TOWN OF ACTON
472 Main Street
Acton, Massachusetts 01720
Telephone (978) 264-9636
Fax (978) 264-9630
planning@acton-ma.gov

MEMORANDUM

To: Planning Board **Date:** July 14, 2009
From: Roland Bartl, AICP, Planning Director
Subject: Subdivision Rules and Regulations – Proposed Amendments

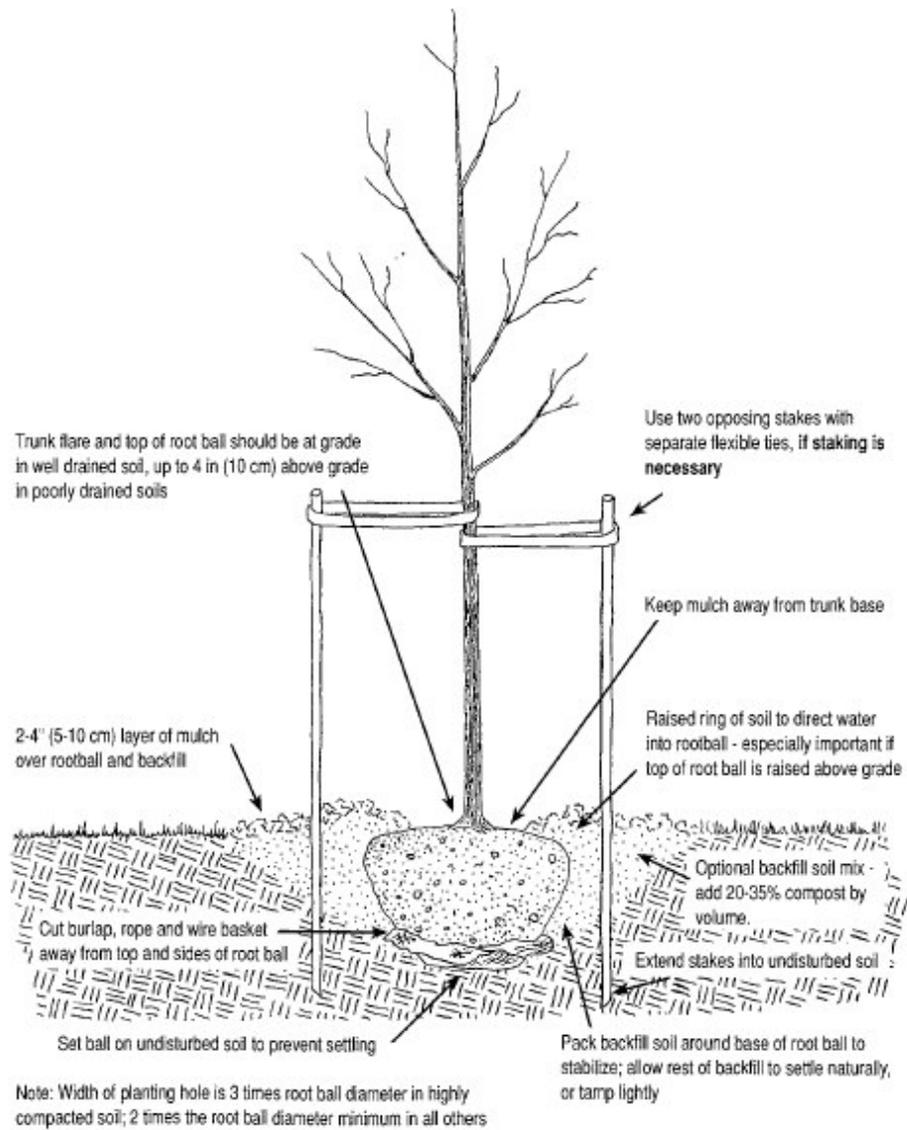
8.1.21 In order to enhance safety and to improve the appearance of the STREET environment, the BOARD may require devices and design features such as neck-downs (encroachments on the standard pavement width, see graphics below) at intersections and at mid-block locations, or additional curves or other features that have a proven effectiveness in reducing vehicular speed. Neck-downs shall be landscaped in accordance with Section 9.8 and the Standard Planting Detail in Appendix B using appropriate adjustments to ensure adequate sight distance where necessary in the opinion of the BOARD.
